GAS FURNACES

DS-GF111510

PRODUCT ALERT

Units Involved: R92P, R95P, R95T, R96P, and U96V-All Inputs

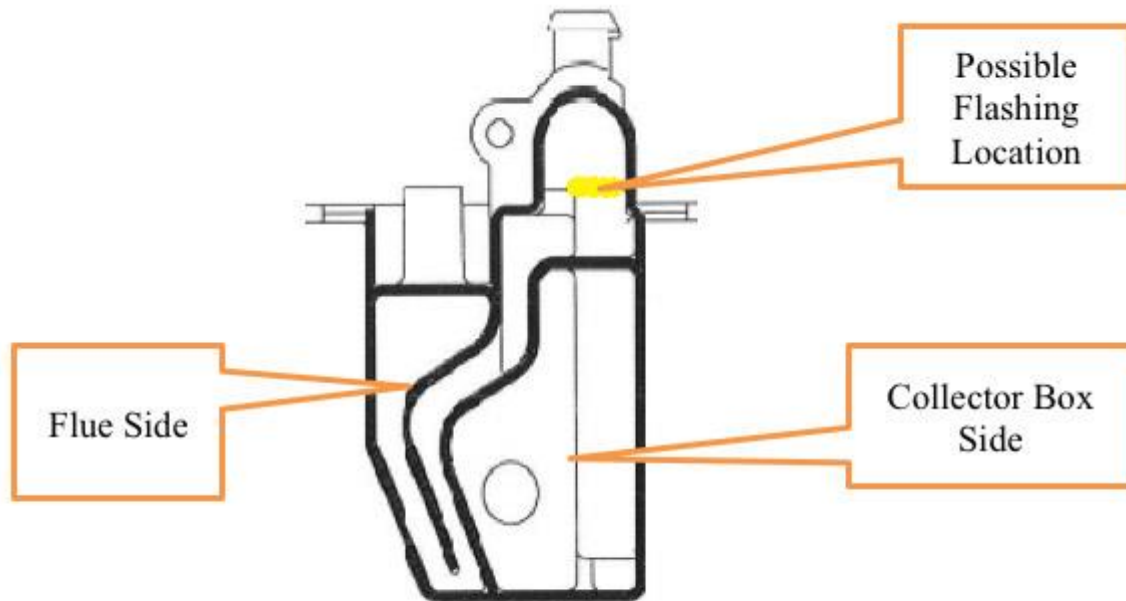
A few furnaces manufactured within date code W0515 through W3415 may experience a failed drain trap. Fault code 59 water sensed/blocked drain and Fault code 10 soft lockout will be alternating on the seven segment LED's with a call for heat if the drain trap is defective. The drain trap defect is due to a maintenance issue in a drain trap mold resulting in flashing, extra plastic material overflowing in the molding process, sealing the collector box side of the trap. The drain trap molds have been corrected and additional maintenance steps have been put in place to prevent this issue from occurring in the future. Additionally, 100% inspection of drain traps was implemented September 30th by both Ruud and our supplier.

Drain traps in furnaces within date code W0515 through W3415 should be inspected during the furnace installation. If flashing is present the drain trap is defective and must be replaced. Drain traps have been inspected and will be provided within normal warranty process through Rheem/Ruud replacement parts. Removing the excess flashing from the drain trap is not recommended. For reliable furnace operation the drain trap should be replaced. Please contact your assigned district technical representative with any questions.
